Change Notice

IS Series

Changes to Logo, Location & Production for IS 36 x 24 LCD Pushbuttons & Displays

Changes for IS Series
36 x 24 LCDs

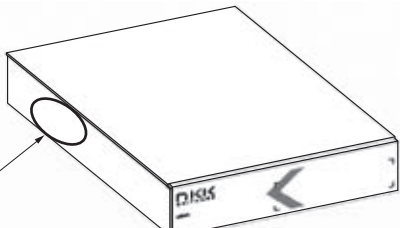
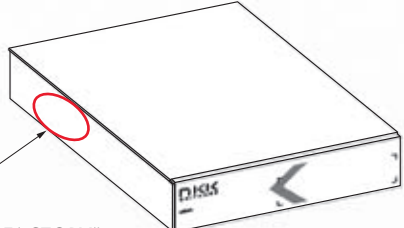
The location of production will change for IS 36 x 24 LCD Pushbuttons and Displays from the Japan factory to the China factory. The place of manufacture will no longer appear on the switches, and the NKK logo will be updated. The lot number on the switch case will have a dot mark above the first digit, and the box in which the switches are packaged for shipping will read "CHINA FACTORY" instead of "JAPAN FACTORY." All of these revisions will apply to standard and custom products. Effected standard part numbers are displayed below.

Switch Case	Logo	Lot Number	Shipping Box
Before Changes	"JAPAN" on Switch Case	Older NKK Logo 	Example of Lot Number 79	 "JAPAN FACTORY" printed on side of box
After Changes	"JAPAN" on Switch Case Removed	NKK Logo Updated 	Example of Lot Number with Dot Mark Above First Digit 7 [•] 9	 "CHINA FACTORY" printed on side of box
